ADDENDUM NO. 2
TO THE DRAWINGS AND PROJECT MANUAL
FOR
FIRE STATION
RACE TRACK LANE, LAKE CITY, FL
COLUMBIA COUNTY BOARD OF COUNTY COMMISSION
ARCHITECT'S PROJECT NO. 0715
CRAIG SALLEY & ASSOCIATES, ARCHITECTS, GAINESVILLE, FLORIDA

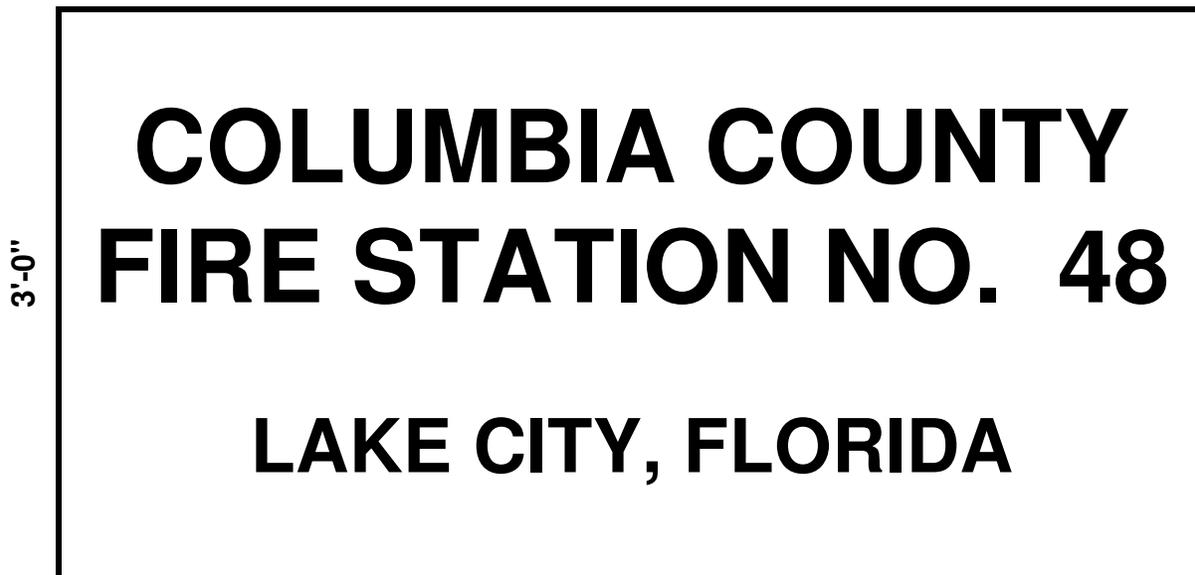
1. **PROJECT MANUAL, SECTION 10900 – MISCELLANEOUS SPECIALTIES:** Refer to Paragraph 1.01 and add Item G. MARQUEE SIGN. Contractor shall furnish and install a 3' high x 6' wide, aluminum and fiberglass, double post and panel, internally illuminated sign similar to that of Series 4210, as manufactured by Apco, Atlanta, GA, www.apcosigns.com.

Aluminum support posts shall be rectangular, approximately 3"x 8", with support mounting plates. Provide high output, 120 V, fluorescent lamps, horizontally mounted with low temperature start up ballasts.

Signage shall be in Helvetica lettering in color as selected by Owner and shall read as follows:

6'-0"

Provide 12" x 12" x 48" deep footings with four #5 reinforcing bars under each support post. Bolt support posts mounting plates to concrete supports with 3/8" by L.A.R. for 120 mph wind loading. Provide all electrical connections, disconnect, all as required for a complete Code compliant installation. See Sheet E-1 of the Drawings for location, electrical requirements, etc. Final location of sign to be determined by the Owner.
